**NEW CAPE MAY COUNTY LIBRARY
STONE HARBOR BRANCH (GA# 07-22)
CAPE MAY COUNTY BOARD of CHOSEN FREEHOLDERS
Addendum #2 – COVER PAGE
June 30, 2011**

**NEW CAPE MAY COUNTY LIBRARY
STONE HARBOR BRANCH (GA# 07-22)
CAPE MAY COUNTY BOARD of CHOSEN FREEHOLDERS
Addendum #2
June 30, 2011**

Re: Stone Harbor Branch Library Site Addenda Revision, revised through 6/15/11

ADDENDUM NO. 1 UPDATE
 ADDENDUM NO. 2 UPDATE
 06/13/11 KWS
 09/23/11 KWS
 CAPE MAY COUNTY LIBRARY
 STONE HARBOR BRANCH
 95TH STREET & BEACH
 STONE HARBOR, NEW JERSEY 08247
 SITED FOR BID 05-09-11
 DALE M. FOSTER
 COUNTY ENGINEER
 OFFICE OF THE COUNTY ENGINEER

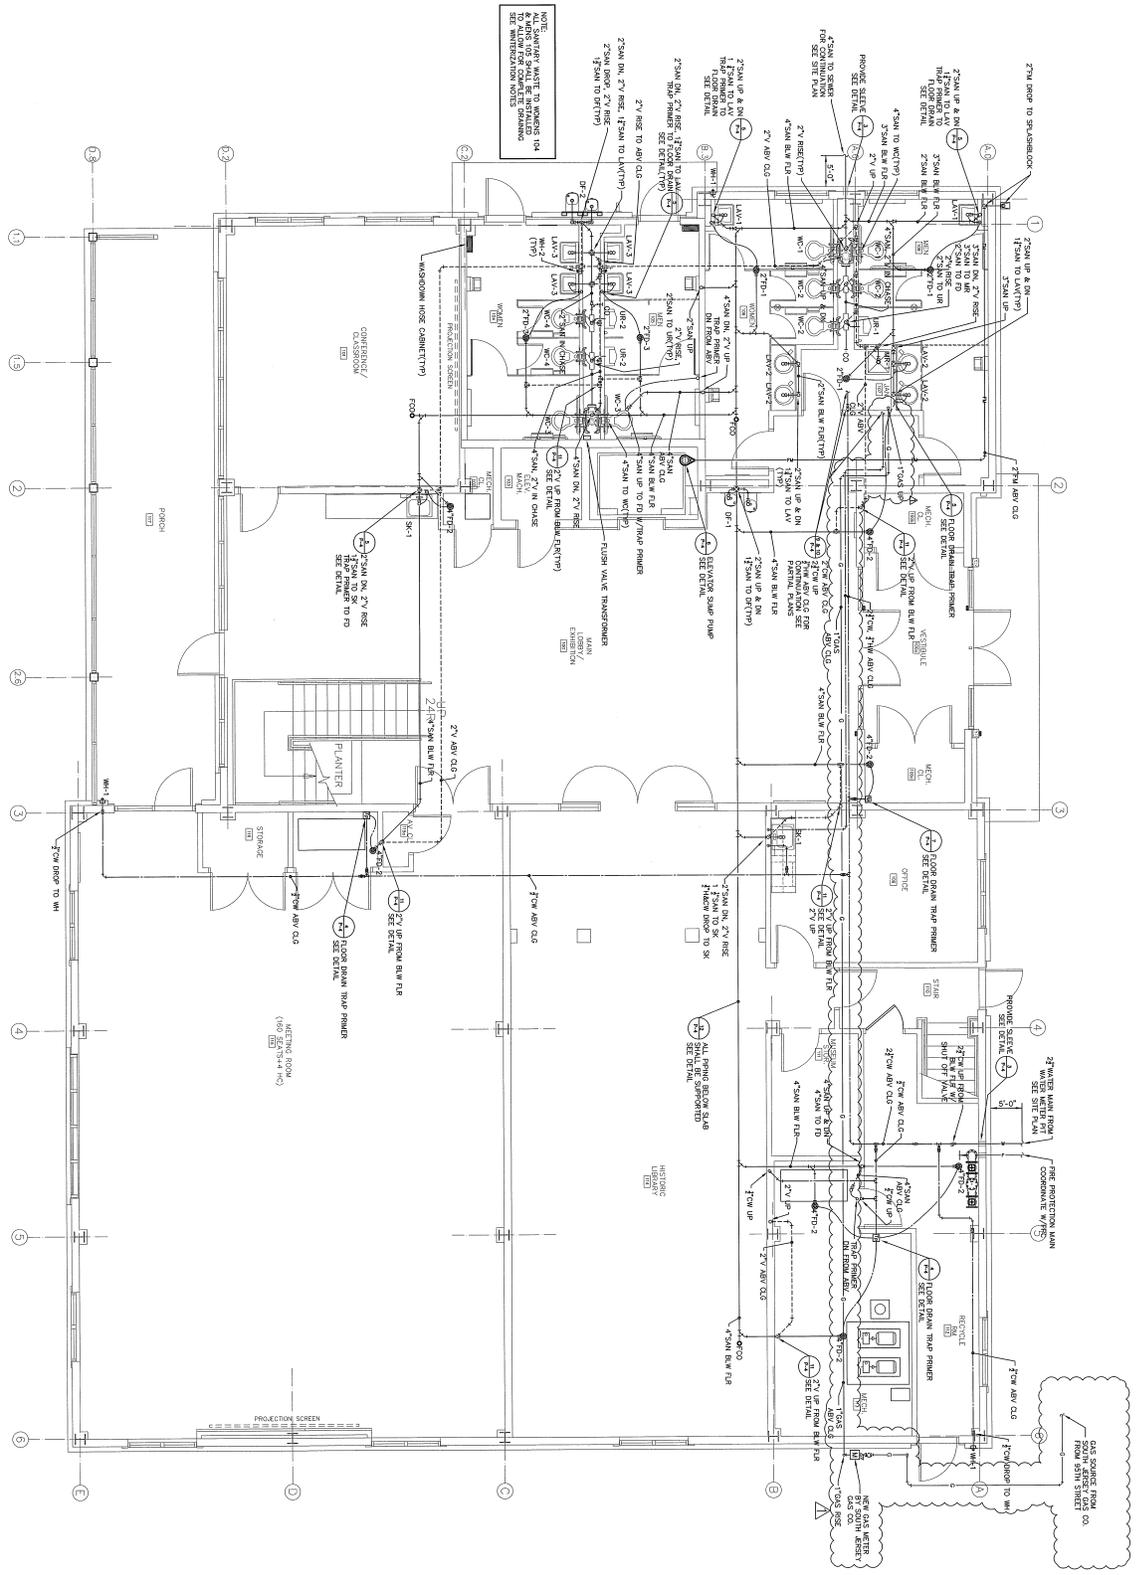
1. A proposed depressed curb has been added along the westerly side of the parking lot to protect the edge of the new pavement. Stormwater must pass over this depressed curb to discharge from the parking lot, see sheets SP-2 and SP-3.

2. Grading has been changed adjoining the exterior bathrooms to assure ADA compatibility, see sheet SP-3.
3. Some curb and sidewalk grades have been changed and additional elevations added to the plan to address new guidance on handicap ramp accessibility and clarify questions regarding depressed curb areas, see sheet SP-3.

6. A Double Faced Handicap Parking Space Sign and Detail has been added to the plan, two are required, see sheets SP-2 and SP-6.
7. Parking lot striping and handicap space symbols have been added to the plan, see sheet SP-2.

8. Rim and invert Elevations of the leaching tank and inlet have been added to the plan, see sheet SP-2.
9. The proposed water main, domestic water service, fire service and hydrant, not in contract, have been changed at the request of the Borough of Stone Harbor, see sheet SP-2.

10. A natural gas service has been added to the plan, see sheet SP-2.
11. Existing and proposed curb and depressed curb hatch styles have been changed to improve readability, see sheets SP-2, SP-4, SP-5 and SP-7.

Offsets from the Northerly and Easterly property lines to the new building have been added to Sheet SP-2. SP2, and SP4 have been redrafted with new hatch patterns, line weight and darkened to improve readability of the existing curb, proposed curb and proposed depressed curb.

Please email or forward a clear copy of site drawing SP-2. From the drawing provided and purchased by us from the County is unclear.(sic) From the key for depressed curb, it appears that the designer is showing depressed curb behind the barrier curb along the roadway, and that much of the site is enclosed by barrier curb. A clear drawing showing limits and items labeled is requested.

Drawing SP 2 shows a 2" meter pit for a 2" water service by Stone Harbor. Drawing P-1 shows that service is a 2.5" service. Please clarify what is required for the domestic water service.

The limits of proposed curb is unclear. Is any of the curb by the mulch islands and lower entrance curb being replaced, or is constructed new? (re dwg SP2, SP5)

Sheet SP2, SP3 and SP5 have been revised to show a new gas service extending from the existing main on the south side of 95th Street to the public bathroom area of the new building. The utility supply question should be routed to the Mechanical Engineer.

Sheet SP-2 has been reissued to provide more readable hatching and lines to delimit curbs and depressed curbs. Sheet SP 3 shows the edge of pavement and top of curb elevations. Where they are the same the curb is flush with the pavement. Please note some grading is changed in the revised plans and additional spot elevations have been added for clarity. I would remind the bidders to make a site visit prior to bidding as required by the documents. Sheet SP-7 notes that there is a concrete wall to remain in place along the notherly boundary of the site.

Two side yard setbacks from the northerly property line to the northerly wall of the proposed building have been added to Sheet SP2. These setbacks are equal, indicating the building is to be parallel with this property line. A rear yard setback of 13 feet from the easterly property line to the northeasterly corner of the proposed building has been added to sheet SP2. An Elevation benchmark and control point coordinates will be provided to the successful bidder's surveyor. No survey stakeout will be provided by the Owner.

Sheet SP-2, at the request of Stone Harbor Borough, shows the water service to be provided will be 2 inch.

Sheets SP-2, and SP-4 have been revised to improve readability. The hatch types and colors representing existing curb to remain, proposed curbs, and proposed depressed curbs have been updated to make them more readable. The grading plan, SP2, shows the pavement and top of curb elevations to clarify the reveal of the proposed curbs. A proposed depressed curb has been added along the westerly side of the parking lot to protect the edge of the new pavement.

Project No: 07-22
 Date: 05-08-11
 Scale: AS SHOWN
 8th FLOOR
 PLAN
P-1

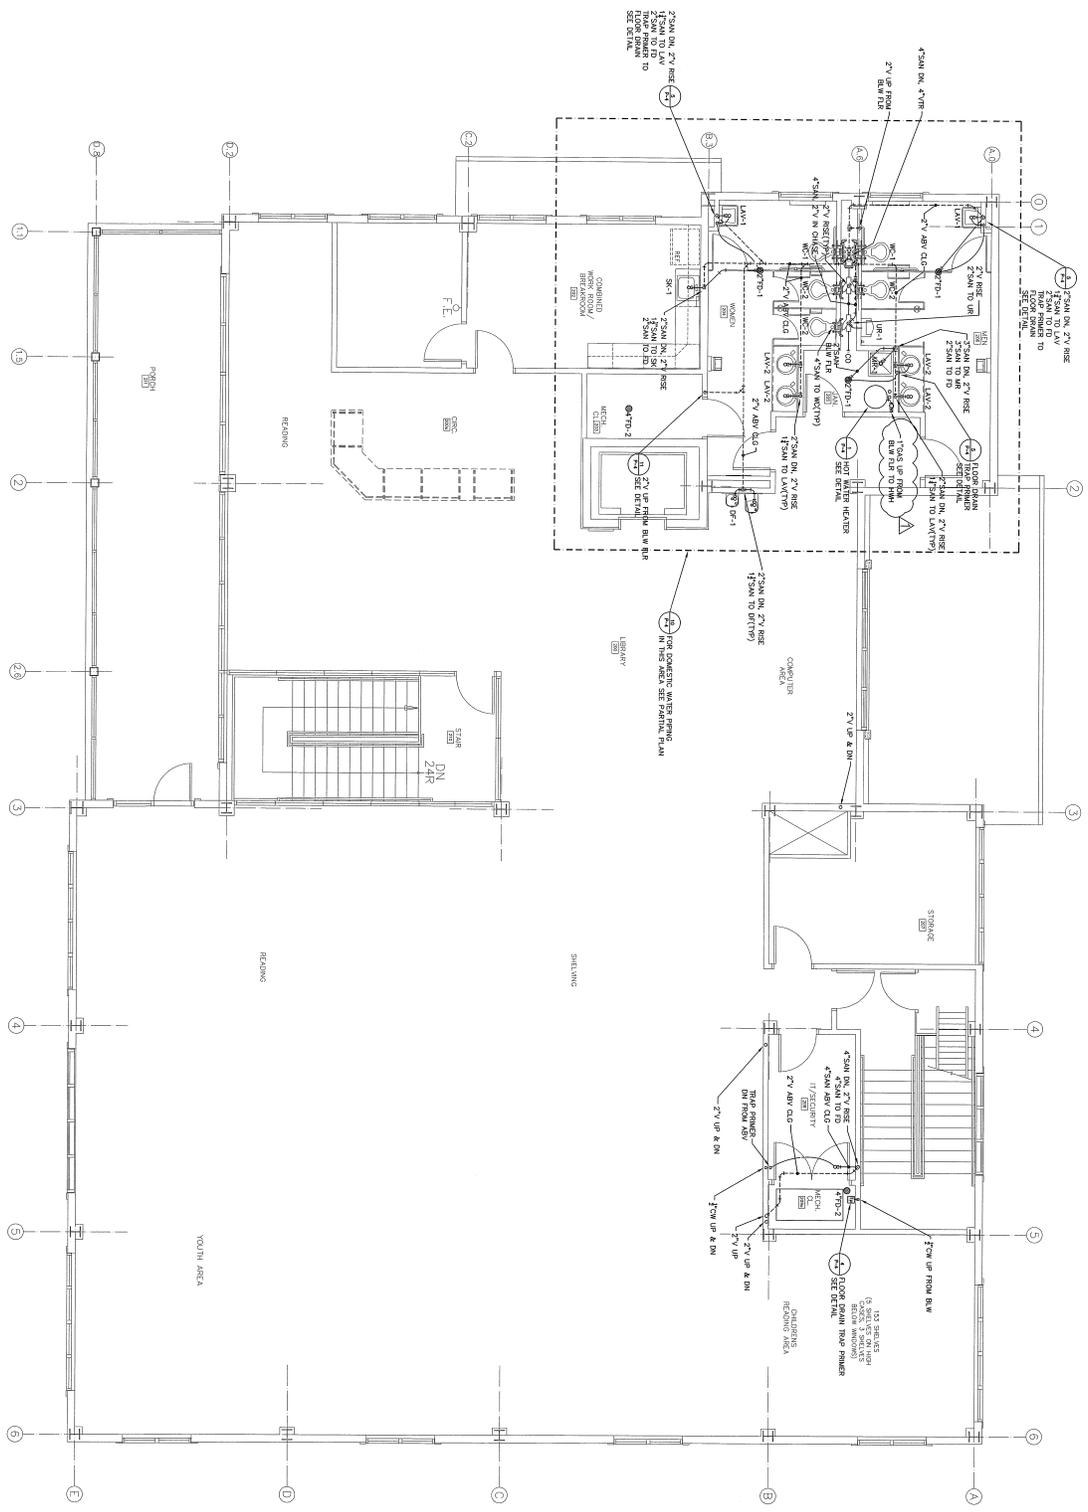
5. Delete Plumbing Drawings P-1, P-2 and P-5 in original bid package, and replace with the attached revised P-1, P-2 and P-5 Drawings with the latest revision dated June 13, 2011.
